Highway Development Management Consultation Response

Planning Application Ref: PL/2026/02458

Site Address: Land East of Eastern Way, Melksham

Recommendation: Holding Objection, additional information/ revisions required

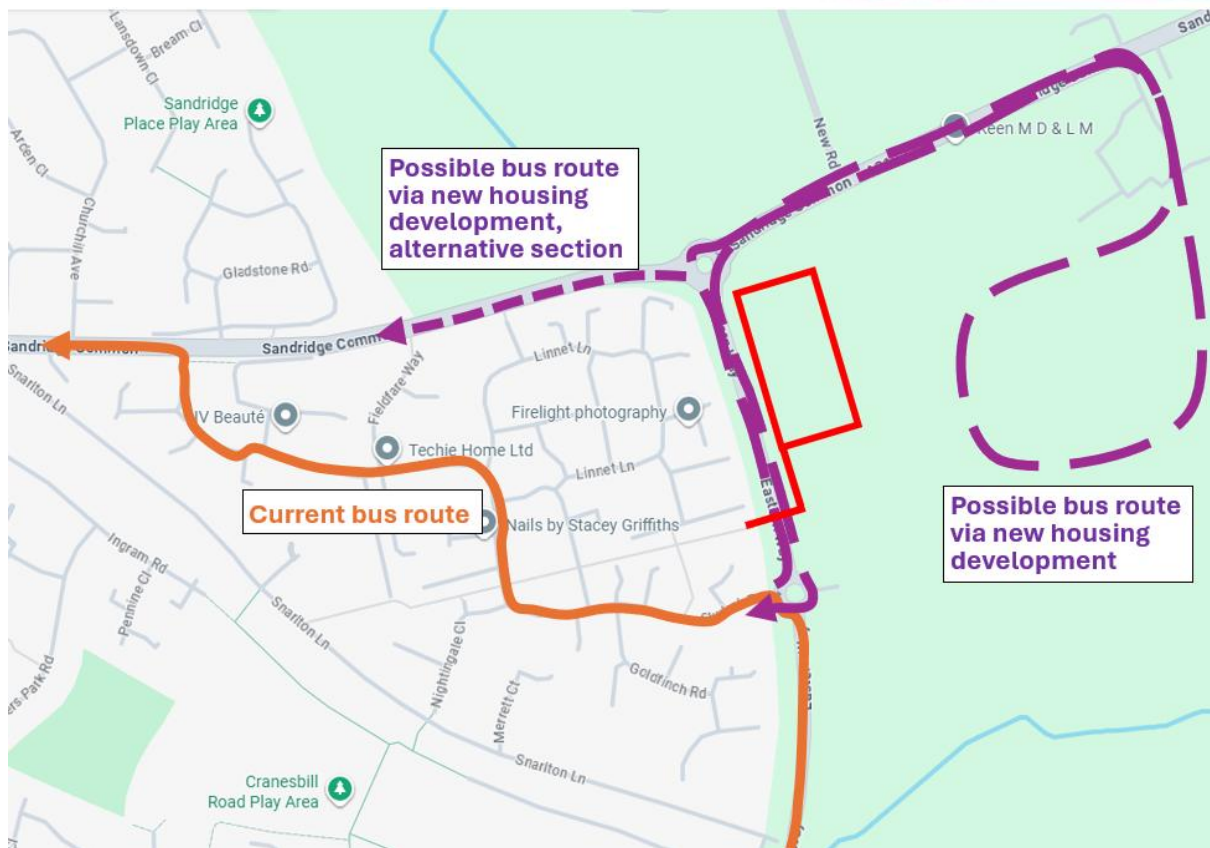
A new dropped kerb will be required on Sandridge Common to allow cyclists to leave the carriageway and enter the site from the North, along the internal 3m wide path towards to cycle parking stands.

Additionally, the new access road is 9m wide and shows a tactile crossing point for peds/cycles. This width, along with the potential of over 200 vehicle trips in the peak hour periods, would make crossing here extremely difficult and this thus needs to be reconsidered to allow suitable crossing opportunities here.
